Access Compliance Report

Public Rights-of-Way

(Curb Ramps)

Intersection ID: 29216	Main Street: BAUCOM_RD	Cross Street: BRATHAY_CT	Location: NW
ADA ID: 6B628A476F83	Ramp Type: Perp	Initial Pass/Fail: Fail	Overall Compliance: No
			Severity Score: 21.25

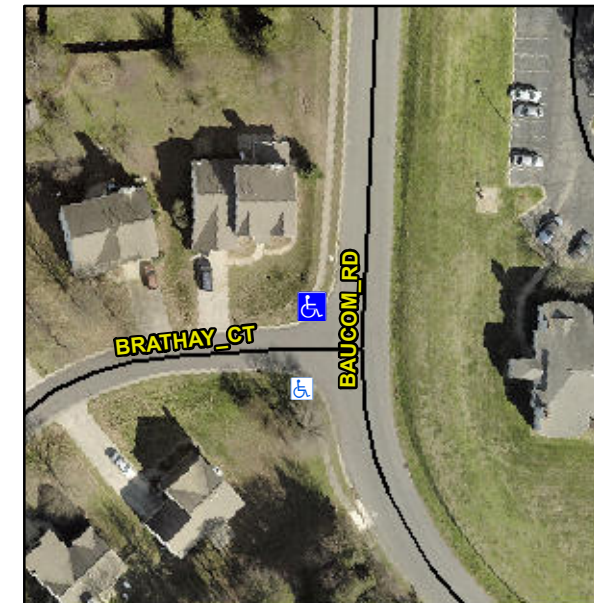
Not Found, R304.5.1, R304.5.3

Compliance	Description	Data	Compliance	Description	Data
N/A	Ramp Length (in)	48.0	Yes	Ramp Slope (%)	7.0
No	Ramp Width (in)	45.0	No	Ramp XSlope (%)	5.5
N/A	Flare Type LT	N/A	N/A	Flare Type RT	N/A
N/A	Flare Slope LT (%)	N/A	N/A	Flare Slope RT (%)	N/A
N/A	Flare Traversable LT?	N/A	N/A	Flare Traversable RT?	N/A
N/A	Landing Length (in)	N/A	N/A	DWS Provided?	N/A
N/A	Landing Width (in)	N/A	N/A	DWS Contrast?	N/A
N/A	Landing Slope (%)	N/A	N/A	DWS Length (in)	N/A
N/A	Landing X Slope (%)	N/A	N/A	DWS Full Width?	N/A
N/A	Landing Curb? (Y/N)	N/A	N/A	DWS Offset (in)	N/A
N/A	Shared Landing?	N/A			
N/A	Gutter Ponding?	N/A	N/A	Gutter Slope (%)	N/A
N/A	Gutter Lip Ht (in)	N/A	N/A	Gutter X Slope (%)	N/A
N/A	Painted X Walk1?	No	N/A	Painted X Walk2?	N/A
	X Walk 1 Direction	To S		X Walk 2 Direction	N/A
N/A	X Walk 1 Width (in)	N/A	N/A	X Walk 2 Width (in)	N/A
	X Walk 1 Slope (%)	0.7		X Walk 2 Slope (%)	N/A
	X Walk 1 X Slope (%)	4.0		X Walk 2 X Slope (%)	N/A

Remove & Replace Entire Ramp.
